RE: LOWER BROADWAY ADDITION (M14-D22). ENGINEER'S CERTIFICATION FOR SUBDIVISION CERTIFICATION. ENGINEER'S CERTIFICATION DATED 7-9-96.

RE: LOWER BROADWAY ADDITION (M14-D22). DRAINAGE REPORT FOR GRADING PERMIT APPROVAL. ENGINEER'S STAMP DATED 3-19-96.

GRADING AND DRAINAGE PLAN FOR LOWER BROADWAY ADDITION

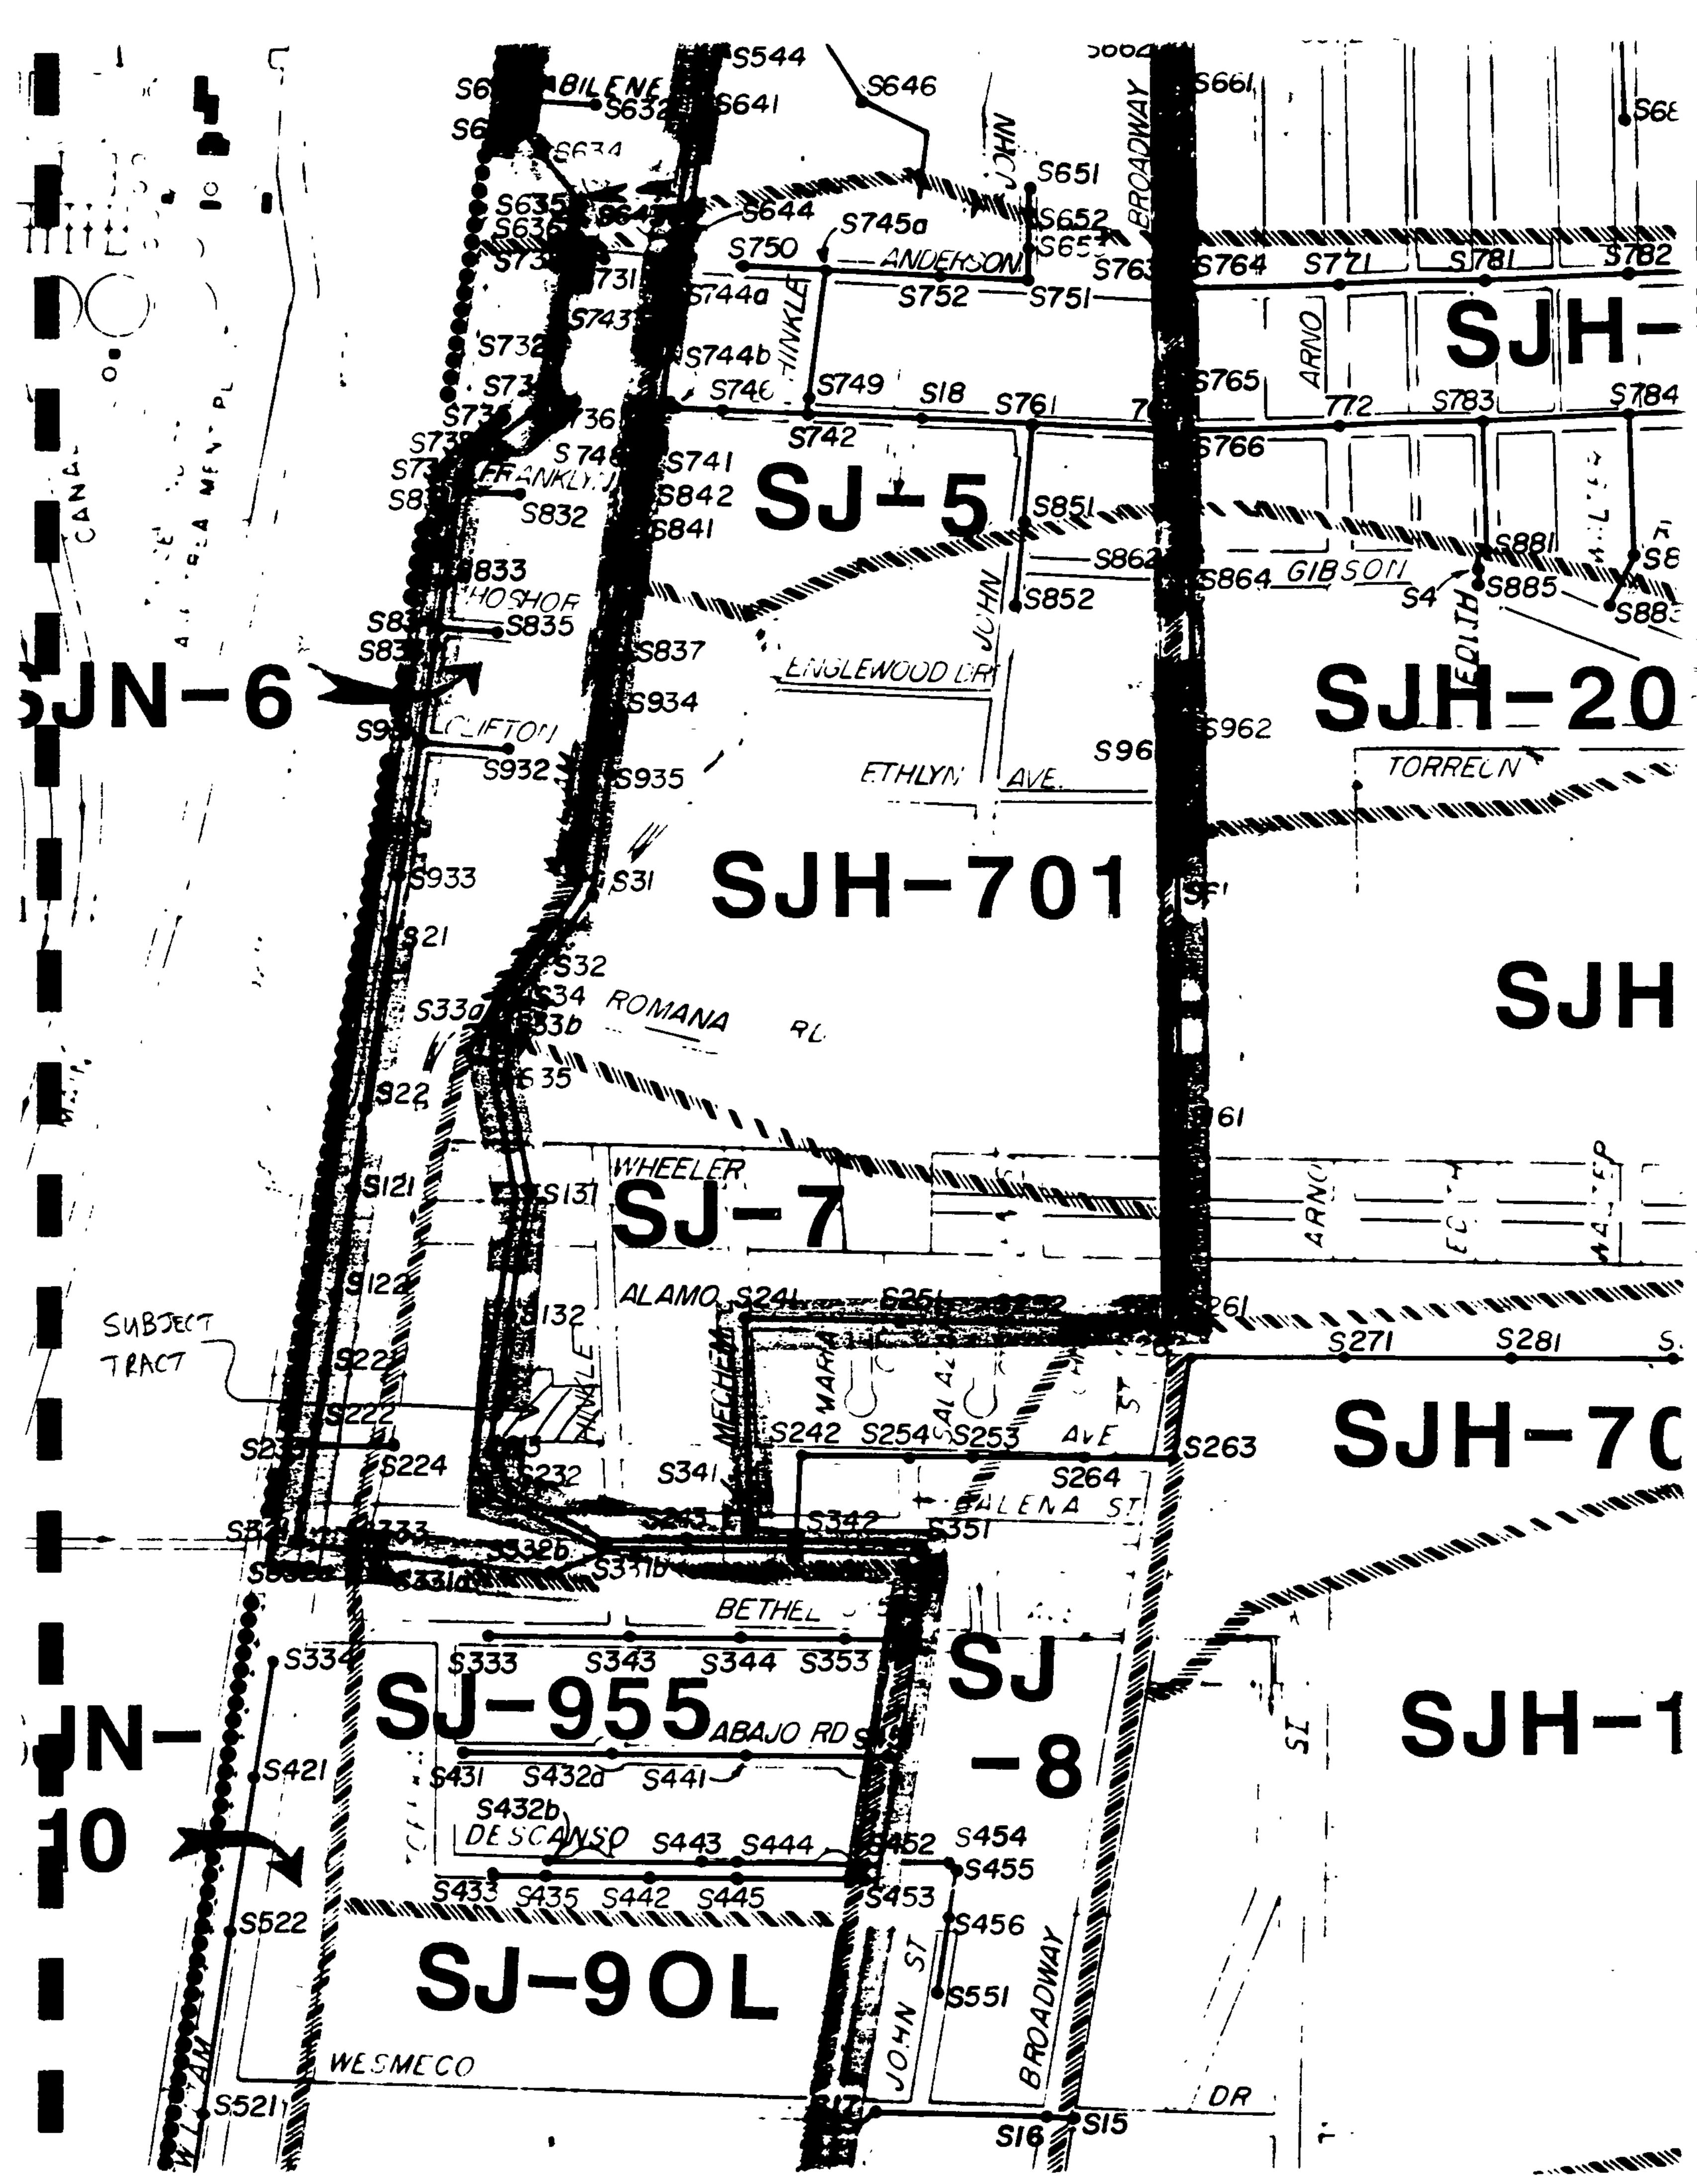
- 1. You will be required to examine downstream capacity to determine an allowable discharge. Keep in mind that if there is no capacity you will not be allowed free discharge and may not necessarily be allowed to discharge at the historical rate.
- 2. Please show locations of driveways. I am unable to tell each lots point of discharge. You are allowed to discharge out a driveway, however, storm water is not permitted to flow over sidewalks.
- 3. What is the flood level elevation? Finish floor must be a minimum of one foot above the flood level elevation.

- 1. Mr. Loren Meinz, the City project manager for the South Broadway Drainage Master Plan area loaned me a copy of that master plan to review for availability of capacities. As referenced in the report, free discharge is allowable.

- I spoke to Mr. Dan Hogan, P.E., the head of the Hydrology section, on April 17, 1996 about this question. Our practice in the past has been to allow residential properties to discharge runoff across their property line into the public right-of-way at any point. Mr. Hogan confirmed that this practice is acceptable, as long as the discharge is of runoff produced on the residential lot in question, and is not from multiple lots, or is some other kind of public runoff. Since these lots are only discharging their own runoff into the right-of-way, the drainage pattern is acceptable.

- As discussed in the report, the finished dirt pads are all more than 1 foot above 100-year water surface elevation. The finished floors will be even higher.
